It Is Not Possible To Rehabilitate The Los Alamos National Laboratory
Characterization Well R-22 For Use As A Monitoring Well To Detect
Groundwater Contamination by
Robert H. Gilkeson, Registered Geologist – Report Date 01-28-09

The New Mexico Environment Department (NMED) Hazardous Waste Bureau (HWB) has ordered LANL to rehabilitate well R-22 by sealing off screens #1, #4 and #5, and installing a pumping system to produce water samples from screens #2 and #3. The expensive rehabilitation required by the NMED is unacceptable for the following reasons.

Figure 2. The as-built construction of LANL characterization well R-22.

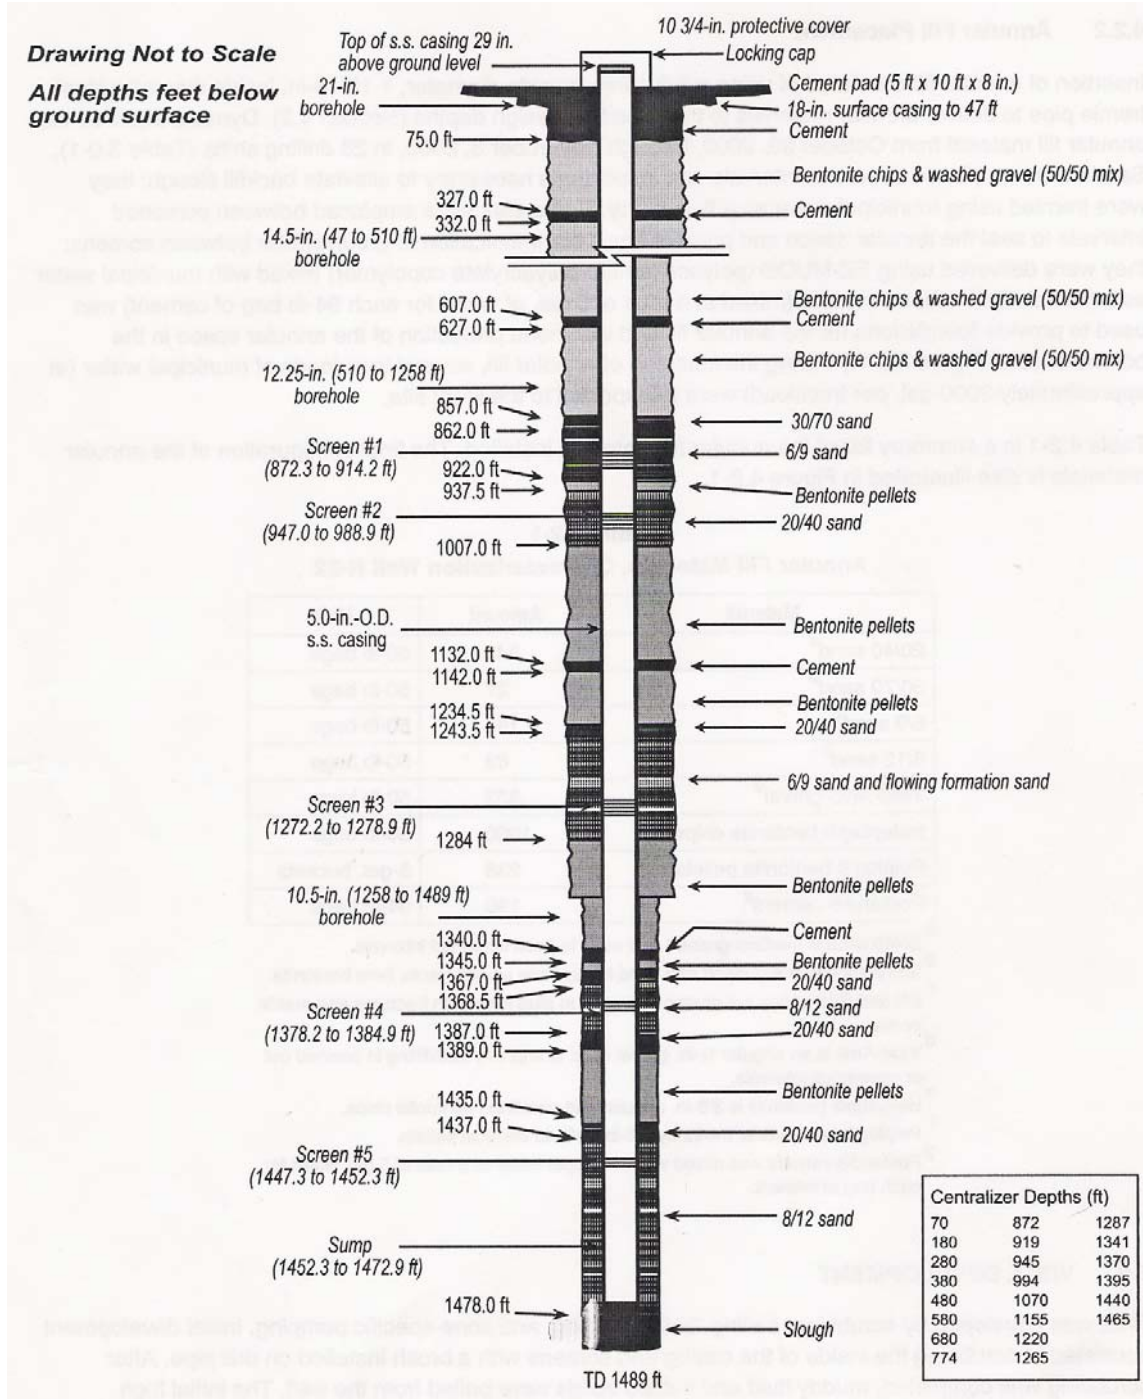
Screen #3 has a short length of only 6.7 ft at a depth from 1272.2 to 1278.9 ft bgs. However, because of a mistake in well construction, the screen is installed inside a 49.5 ft long interval of filter pack sediments in the depth interval of 1234.5 - 1284 ft bgs. The standard industry practice is to limit the zone of filter pack sediments to not greater than five feet above and below the screen.

The LANL Hydrogeologic Workplan¹¹ that was approved by the NMED required the LANL characterization wells to be constructed with the zone of filter pack sediments not greater than two feet above or below the screen. However, for screen #3, the zone of filter pack sediments extends a distance of 37.7 feet above the screen and 5.1 feet below the screen. See Figure 2 for the as-built construction of well R-22.

Figure 3. Summary of Schlumberger^R Geophysics for LANL Well R-22.
Source: LANL Report LA-UR-04-677 (September 2004)

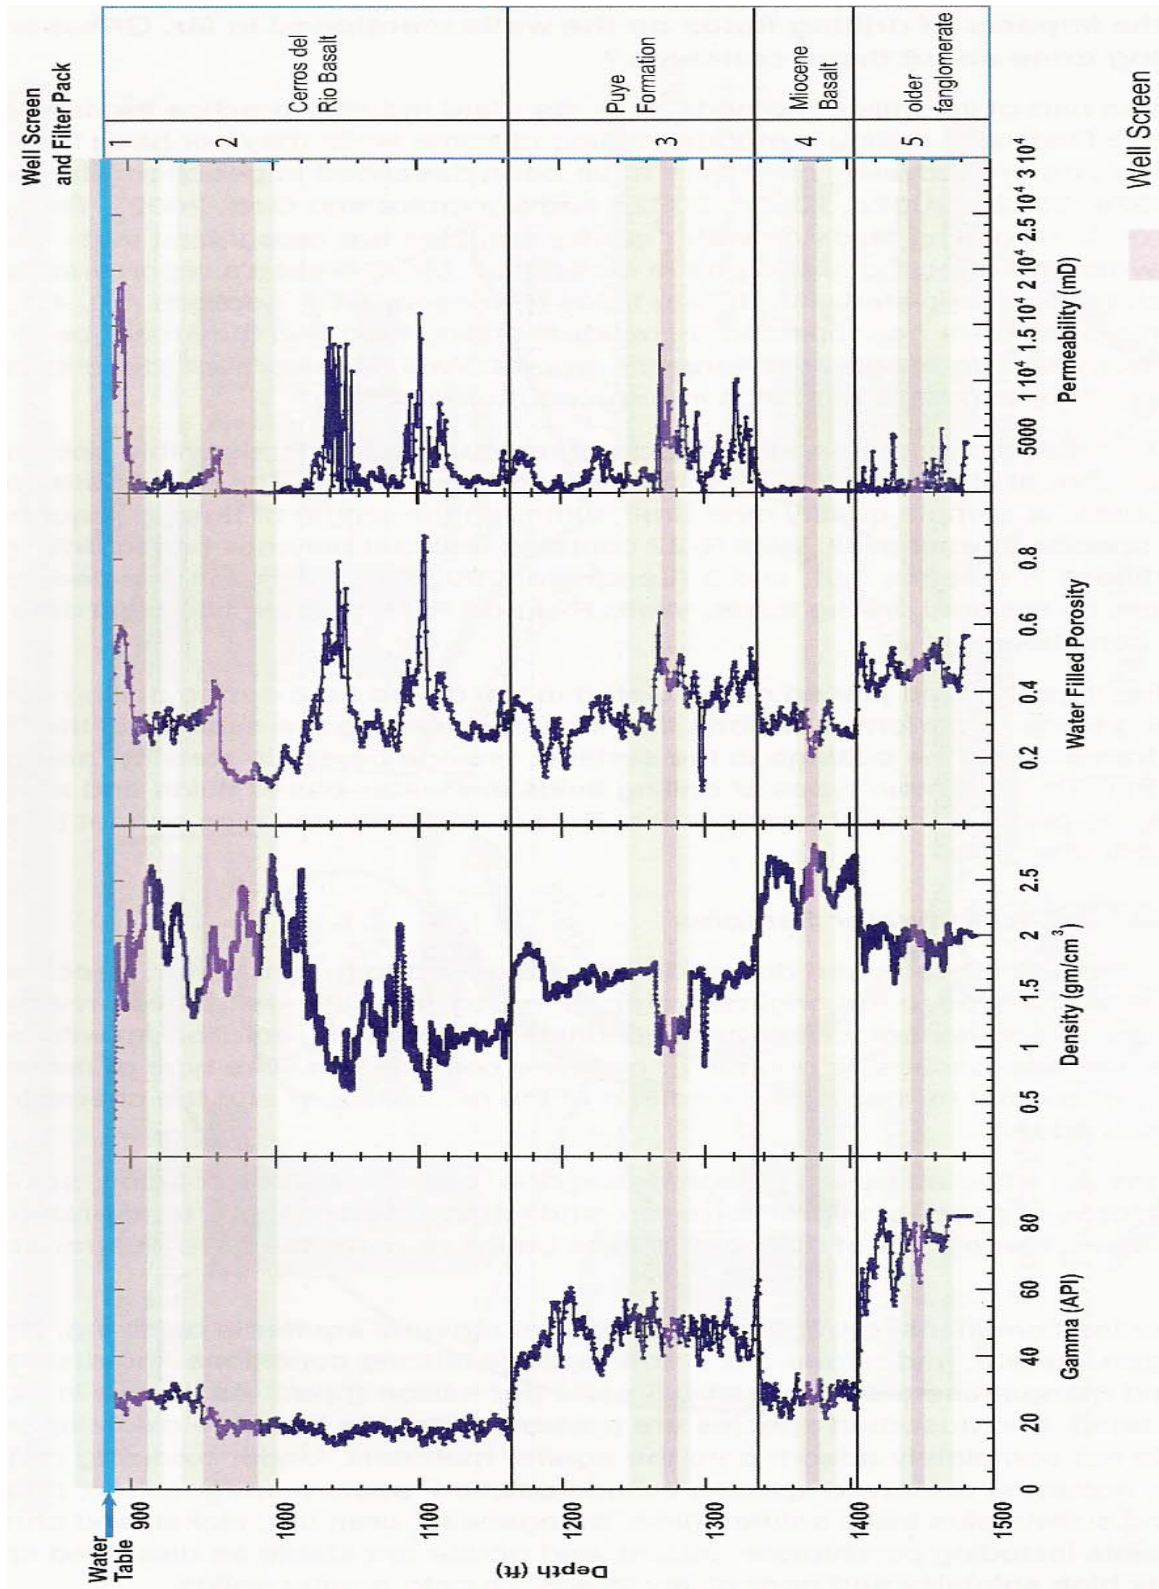
- Screen #3 is installed at a depth of 390 feet below the water table of the regional aquifer. The screen is installed too deep below the water table and below four sections of aquifer strata with high permeability (including the strata at screen #1) that are important to monitor but are not monitored. See Figure 3.

porosity for accepting the cuttings. The Schlumberger^R Water Filled Porosity log in Figure 3 shows a high porosity for the interval of no sample returns. In addition, for the entire borehole, the Schlumberger^R Permeability log in Figure 3 assigns the highest permeability to the interval of no sample recovery at screen #1. For comparison, note the very low permeability on the Schlumberger^R permeability log for most of the interval surrounding screen #2.

Figure 3 shows that the Schlumberger^R geophysics measured an interval of high water-filled porosity, high permeability and low density for the layer of scoria. The

Figure 3 shows that the Schlumberger^R geophysics measured an interval of high water-filled porosity, high permeability and low density for the 45-ft interval of no sample recovery in the interflow layer. The geophysics measurements and the drilling record indicate the interflow deposits are capable of producing large supplies of groundwater.

Figure 5. Schematic of the pipe-based wire-wrap stainless steel well screens installed in many of the LANL characterization wells including LANL well R-22.

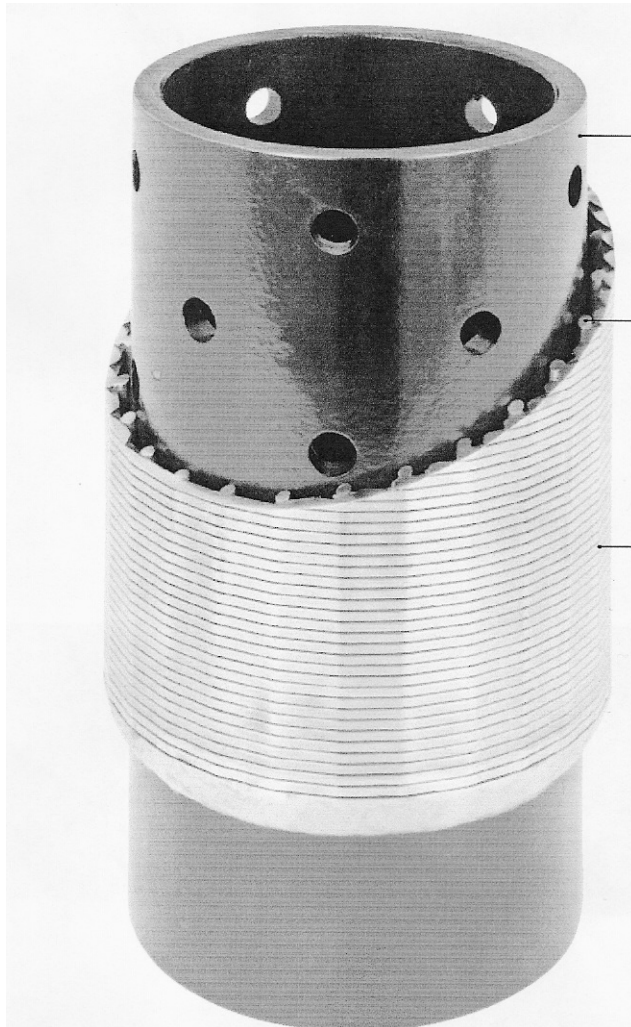
- The well development methods cannot clean the new reactive mineralogy or the bentonite clay grout contamination from the screened interval.
- Indeed, the restrictive pipe-based design of the well screen well prevent the well rehabilitation from even cleaning the grout contamination from the well screen. Figure 5 is a picture of a pipe-based well screen.

The "*cement-tainted fluids that apparently entered through screen #3 during backfilling*" are evidence of a large amount of contamination in the filter pack sediments surrounding screen #3 with the bentonite clay/cement grout that was used to seal the annular space between the well casing and the borehole wall during the construction of well R-22. The grout contamination cannot be cleaned from the screened interval. In fact, the restrictive design of the pipe-based screens installed in well R-22 prevents the grout contamination from being cleaned even from the well screen. The pipe-based design of the well screens is displayed in Figure 5. A pipe is installed inside the stainless steel well screen. The only access to clean screen #3 is by surging water through holes drilled in the pipe. The holes only provide access to only 5% to 10% of the surface area of the wire-wrapped well screen.

The NMED HWB ordered the rehabilitation of well R-22 despite the position of the NMED OB that the pipe-based screens would make the rehabilitation extremely difficult. In fact, the pipe-based screens are one factor that will make rehabilitation impossible.
